From: "Hannah Flynn" <hannah@northpointplanning.com.au>
Sent: Tue, 3 Nov 2026 15:26:14 +1000
To: "Estelle Trueman" <estelle.trueman@townsville.qld.gov.au>
Cc: "Meredith Hutton" <meredith@northpointplanning.com.au>; "Development Assessment" <developmentassessment@townsville.qld.gov.au>
Subject: MCU26/0113 (NP26.357) - IR Response - 198 Ross River Road
Attachments: ONP26.357 - IR Response.pdf

Response to Information Request
Development Application for Material Change of Use – Multiple Dwelling
198 Ross River Road, Aitkenvale and formally identified as Lot 3 on RP711604

Information Request
Planning Act 2016

Application no:	MCU26/0113
Assessment no:	2534063
Proposal:	Multiple Dwelling
Street address:	198 Ross River Road AITKENVALE QLD 4814
Real property description:	Lot 3 RP 711604
Applicant's reference:	NP26.357

Figure 1: Aisle extension requirement

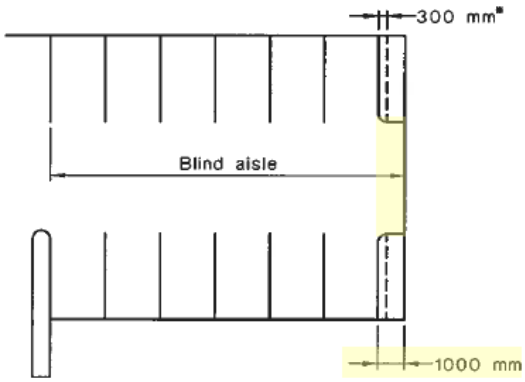
a) Extend the internal parking aisle a minimum of 1.0 metre beyond the last parking space along the southern boundary in accordance with the manoeuvring requirements of AS 2890.1:2004 Parking Facilities Part 1 - Off-street Car Parking (see Figure 1 below).
b) Provide dimensions for all parking spaces, parking aisles and manoeuvring areas to demonstrate compliance with the relevant requirements of AS 2890.1:2004.

Request Item 1 – Car Parking Details
This item requests that the Applicant submit amended site plans demonstrating compliance with Performance Outcome PO13 of the Transport Impact, Access and Parking Code. In response, please refer to the amended site plans provided in **Attachment 2**, which have been prepared to demonstrate compliance with the relevant performance outcome.
Request Item 2 – Refuse Collection Arrangements
This item requests that the Applicant provide evidence that sufficient space is available along the road frontage to accommodate 12 wheelie bins, with adequate separation to facilitate collection. The proposed development can be appropriately serviced through the provision of individual general waste and recycling wheelie bins for each unit. A total of 14.3m of frontage is available along Ross River Road for bin placement and collection,

1 SITE PLAN

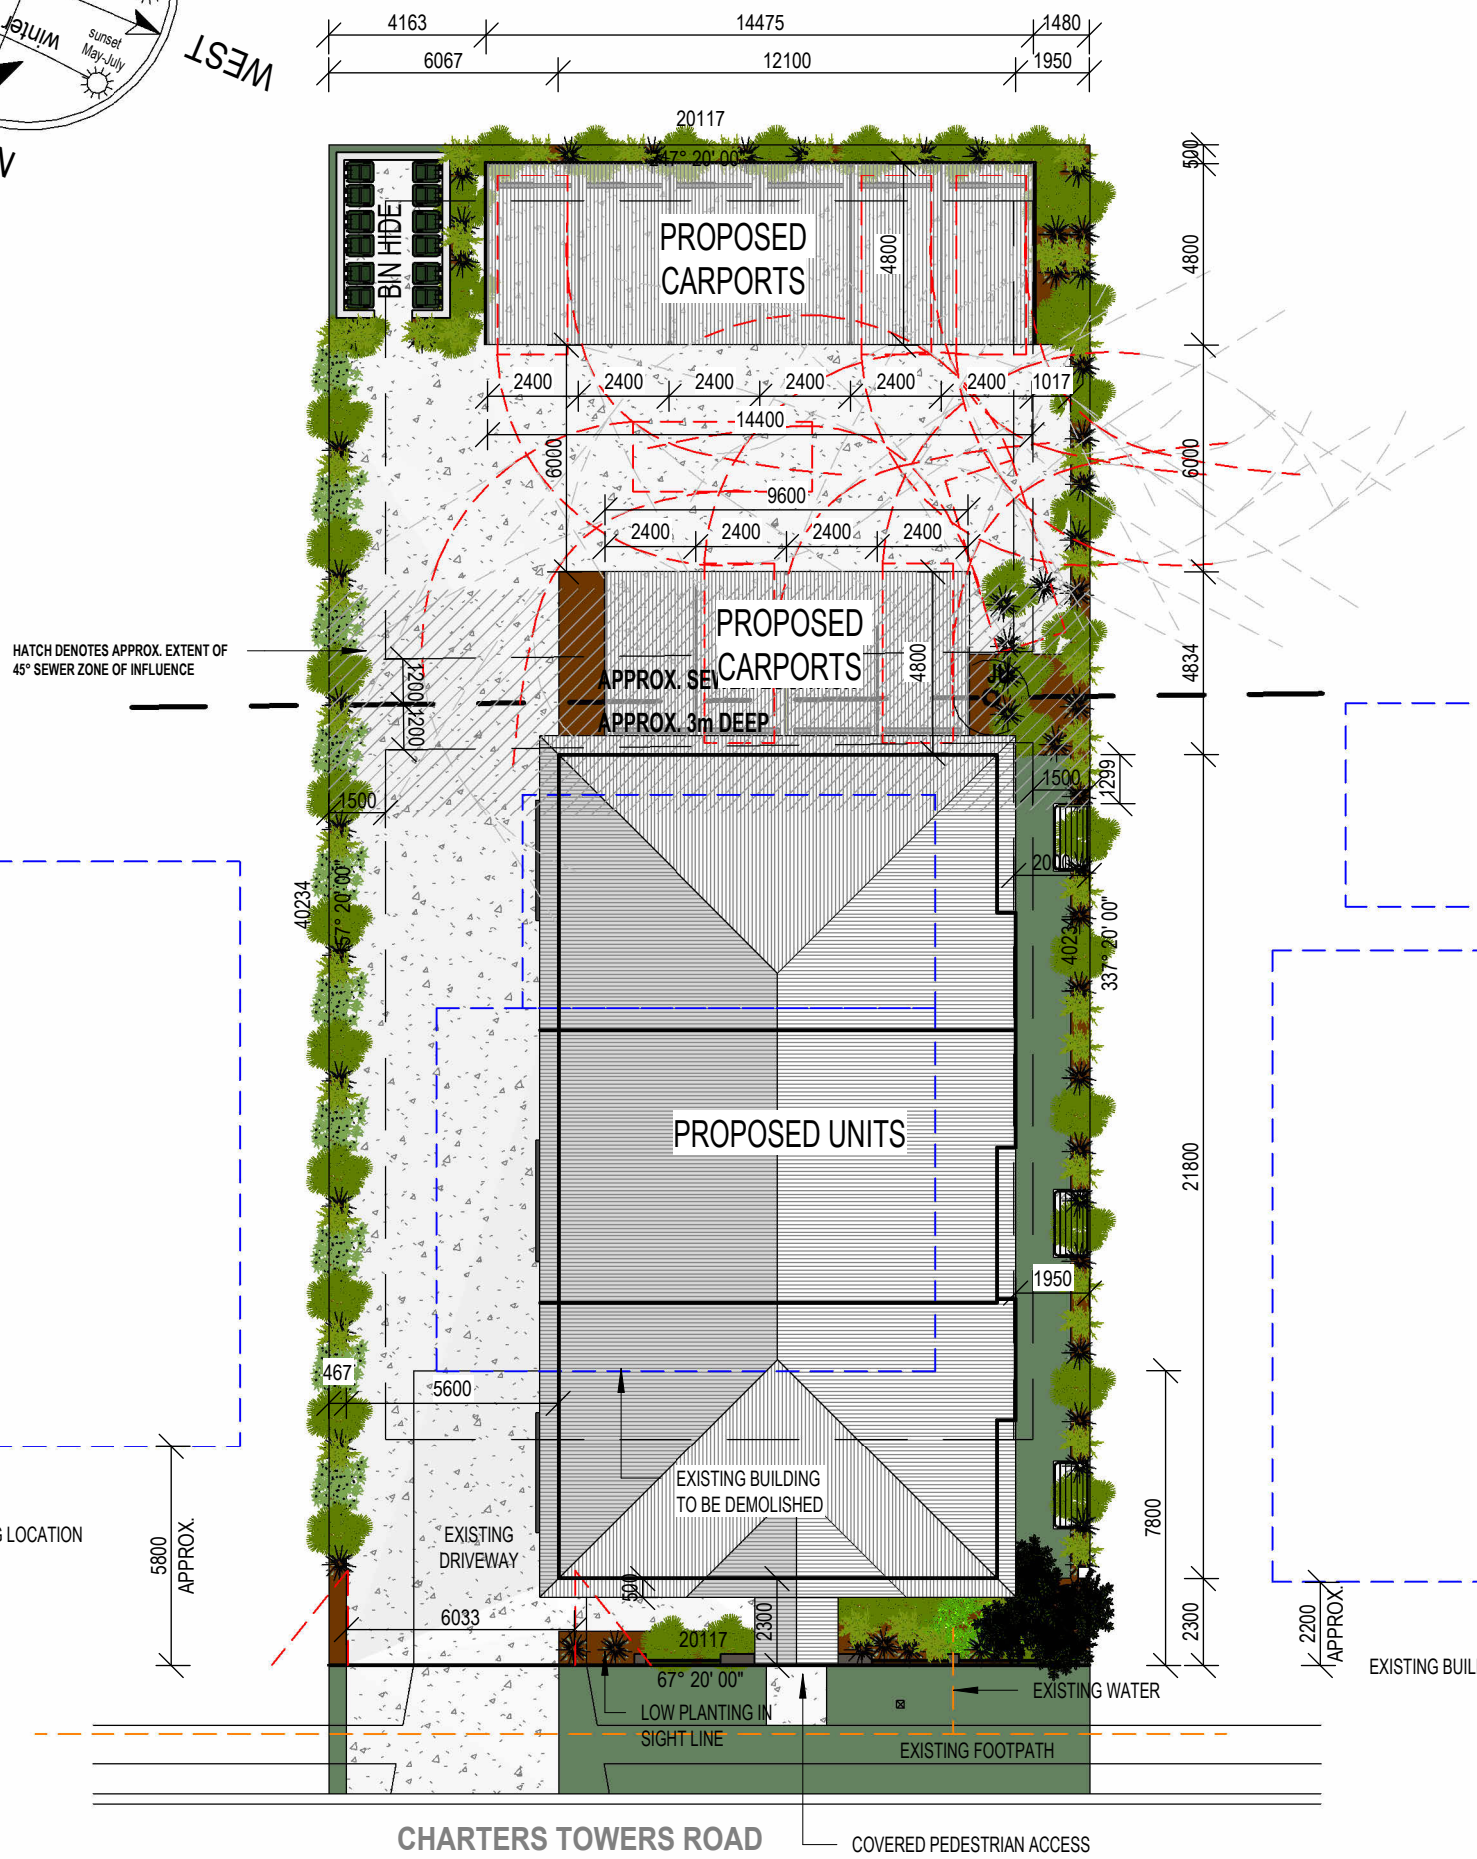
Request Item 2 – Refuse Collection Arrangements
Provide evidence that there is sufficient space along the road frontage to accommodate 12 wheelie bins with adequate separation for collection.

a) Provide amended plans demonstrating safe and separate pedestrian access to the site;
b) Provide a gate house, or other weather protective structure to the pedestrian entry;
c) Increase the amount of landscaping area along the front boundary; and
d) Advise the location of clothes drying facilities and air conditioner condenser units (the latter of which cannot be located on patios/decks).

calculated as the total 19.9m road frontage less the 5.6m wide driveway crossover. Calculations have been undertaken to confirm that the available frontage can accommodate all 12 wheelie bins, comprising general waste and recycling bins for each of the six units, with a minimum separation of 500mm between bins.

The amended plans demonstrate the provision of safe and separate pedestrian access to the site via a dedicated gatehouse, which also provides weather protection at the pedestrian entry.

Landscaping has been increased along the front boundary of the site, providing additional planting opportunities and enhancing the overall landscape presentation of the development.
